PCI-SIG ENGINEERING CHANGE NOTICE

TITLE:	Native PCIe Enclosure Management
DATE:	May 18, 2017, PWG approved for final release August 10, 2017
AFFECTED DOCUMENT:	PCI Express Base Specification Rev. 3.x PCI Code and ID Assignment Specification, Version 1.8 Single Root I/O Virtualization and Sharing Specification Rev 1.1
SPONSOR:	Intel, Dell EMC, Microsemi (On behalf of NVMe-MI Working Group)

Figure 6-x1 Figure: Example NPEM Configuration using a Downstream Port

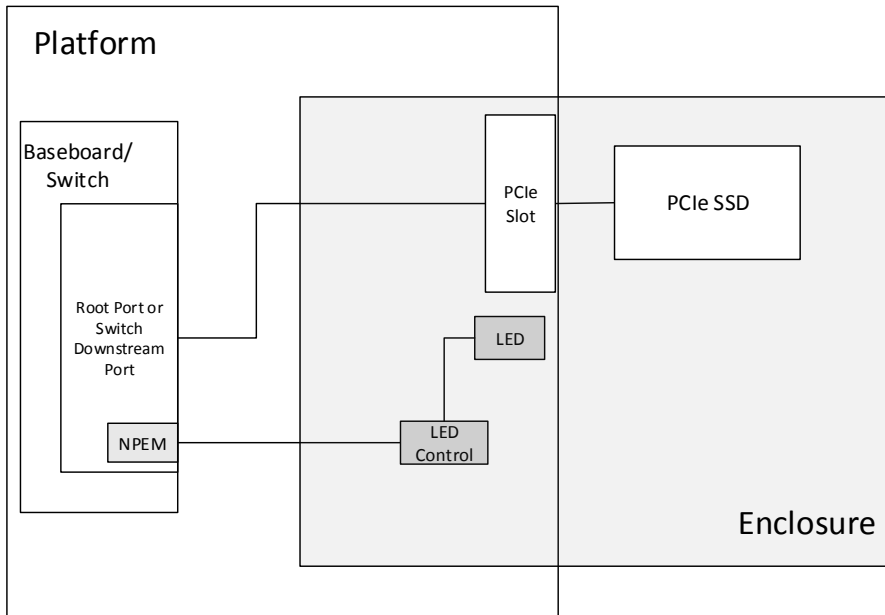
15 An enclosure is any platform, box, rack, or set of boxes that contain one or more PCIe SSDs. The NPEM capability provides storage related enclosure control (e.g., status LED control) for a PCIe SSD. The NPEM capability may reside in a Downstream port, or an Endpoint (i.e., the PCIe SSD). Figure 6-x1 shows an example configuration with a single Downstream Port containing the NPEM capability and vendor specific logic to control the associated LEDs.

Figure 6-x2: Example NPEM Configuration using an Upstream Port

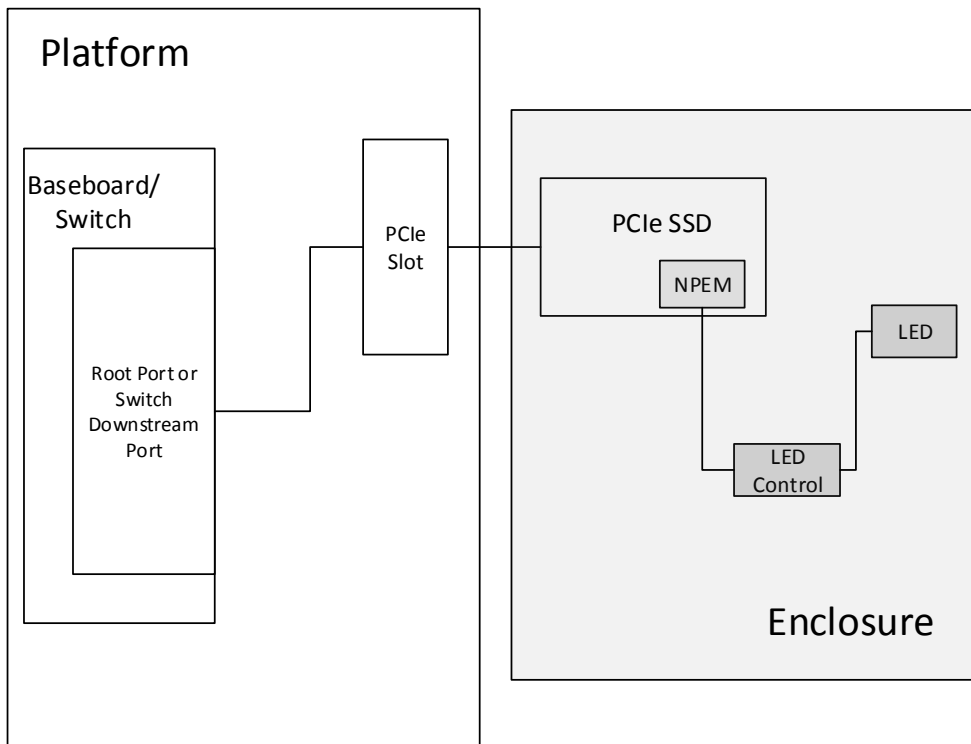
Figure 6-x2 shows an example configuration with the NPEM capability located in the Upstream Port (in this case, the SSD function).

Figure 6-x3: NPEM Command Flow

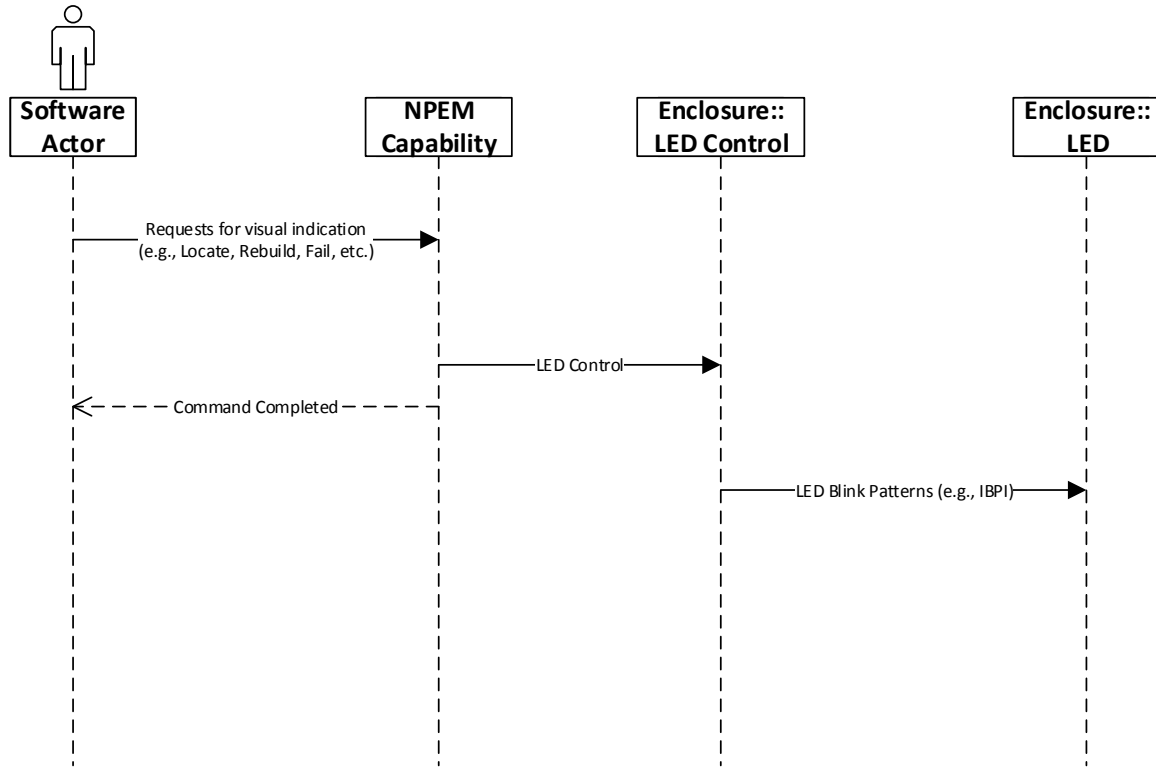
Software issues an NPEM command by writing to the NPEM Control register to change the indications associated with an SSD. NPEM Command is a single write to the NPEM Control register that changes the state of zero or more bits. NPEM indicates a successful

completion to software using the command completed mechanism. Figure 6-x3 shows the overall flow.

Figure 7-x1 NPEM Extended Capability

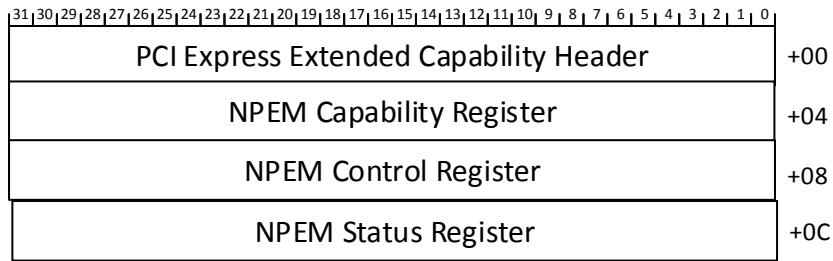
- 5 The Native PCIe Enclosure Management Extended (NPEM) Capability is an optional extended capability that is permitted to be implemented by Root Ports, Switch Downstream Ports, and Endpoints.

Figure 7-x2 NPEM Capability Register

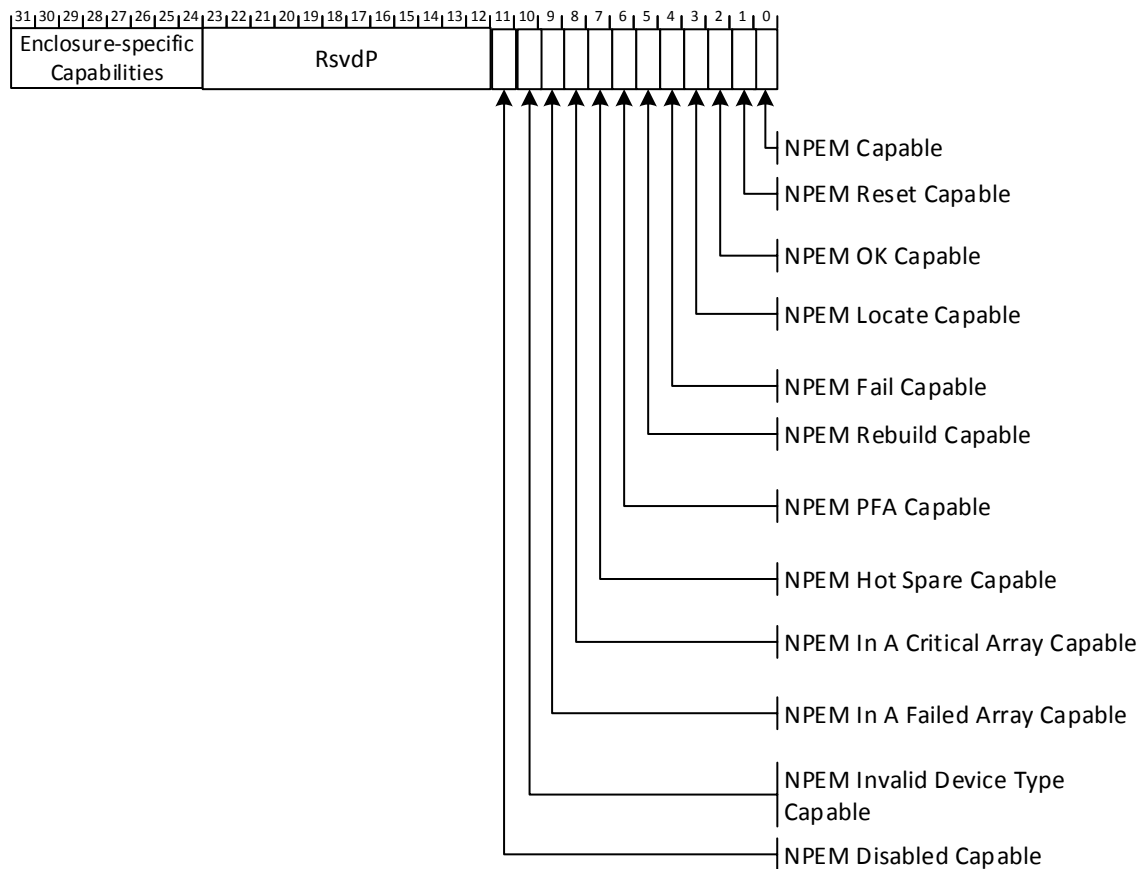
- 5 The NPEM Capability Register contains an overall NPEM capable bit and a bit map of states supported in the implementation. Implementations are required to support OK, Locate, Fail, and Rebuild states if NPEM capable bit is Set. All other states are optional.

Figure 7-x3 NPEM Control Register

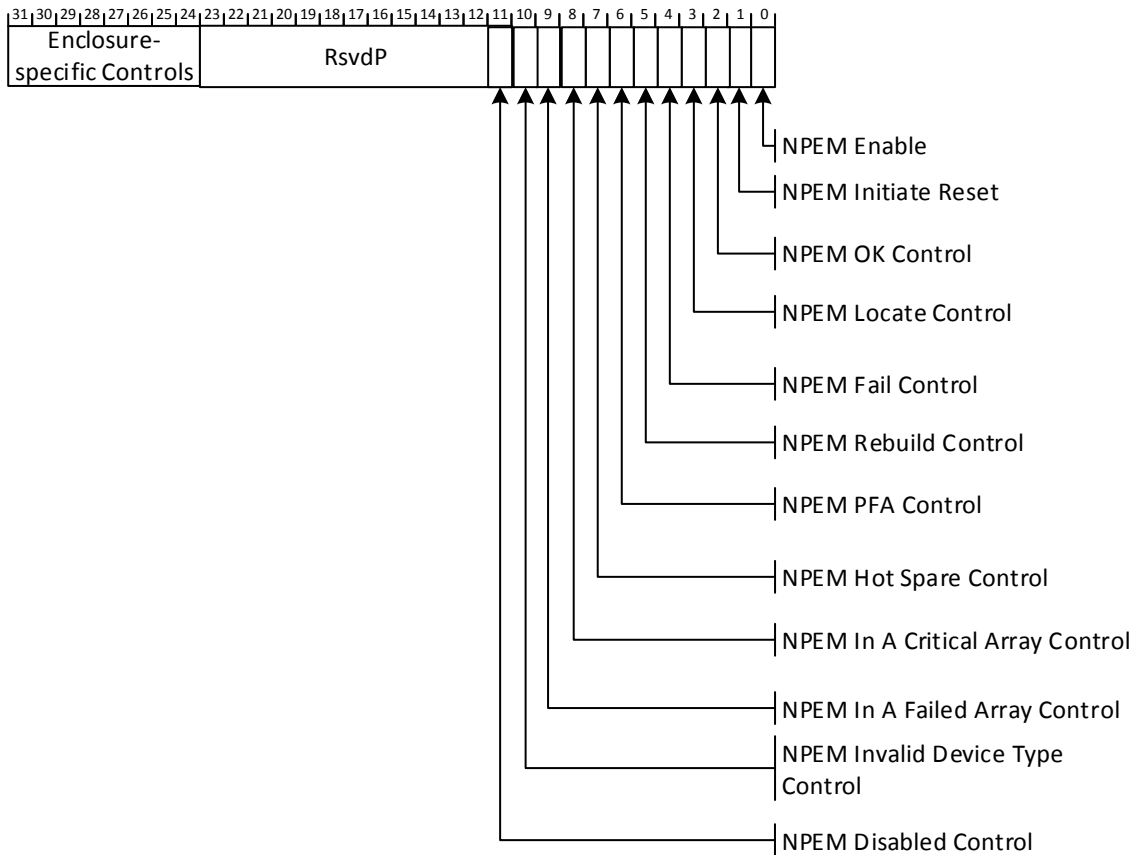
5 The NPEM Control Register contains an overall NPEM enable bit and a bit map of states that software controls.

All writes to this register, including writes that do not change the register value, are NPEM commands and should eventually result in a command completion indication in the NPEM Status register.
